Tanker Q&As and CIs on the IACS CSR Knowledge Centre

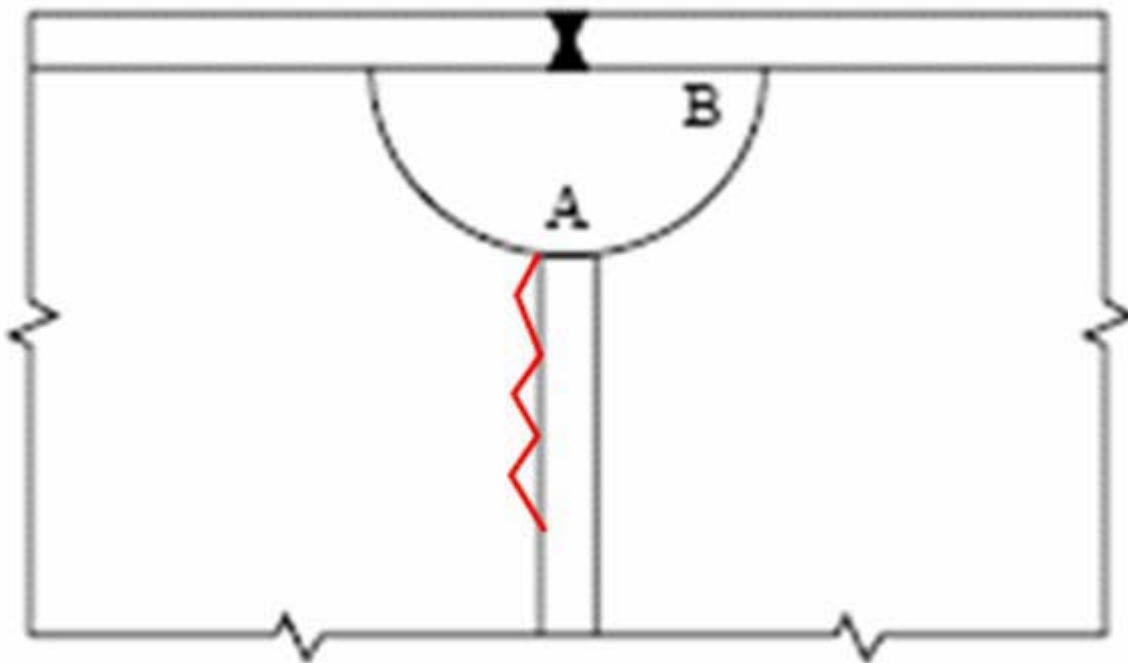
| KCID No. | Ref. | Type | Topic | Date completed | Question/CI | Answer | Attachment |
|----------|----------------|----------|--|----------------|--|---|-------------------|
| 159 attc | 9/3.3 | Question | Required Structural Details to fatigue check | 2007/11/8 | <p>(1) Are the following structural details only required to fatigue check and are the following method for fatigue check applied to each structural detail?</p> <p>(a) longitudinal stiffener end connection</p> <p>(b) scallops in way of block joints on the strength deck</p> <p>(c) welded knuckle between inner bottom and hopper plate</p> <p>(2) We have no fatigue damage of scallops in way of block joints on the strength deck.</p> <p>If the fatigue damage of such part were recorded, we would like to know the damage details such as sketch of damage, number of damage, the longitudinal location including on-deck or under deck, type of longitudinals, elapsed time after service, ship's size.</p> | <p>(1) Yes, your understanding is correct. With regard to item (b), as indicated in Appendix C/1.6.1.1, unless the specification in Section 8/1.5.1.3 for class F2 is satisfied, the scallops in way of block joint on strength deck is to comply with Figure C.1.12, then fatigue check is not required. Only for option II in Fig C.1.12, alternative scallop geometry may be accepted subject to demonstration of satisfactory fatigue check. Please see Appendix C/1.6.1 and Notes to Fig.C.1.12.</p> <p>(2) Fatigue cracks are recorded for half circular scallops in way of block joints in the main for oil tankers trading in harsh environment. The typical crack location is at location A defined in the below figure. The stress concentration factor at this location obtained by FE analysis reads 2.4 for half circular scallops and the fatigue strength becomes critical in case butt welds are located in the bay of the scallop. By elongated scallops as defined by Figure C.1.12 (II) the stress concentration is reduced to about 1.3. More details on ship type, number of damages and elapsed time are however not available.</p> | Y |
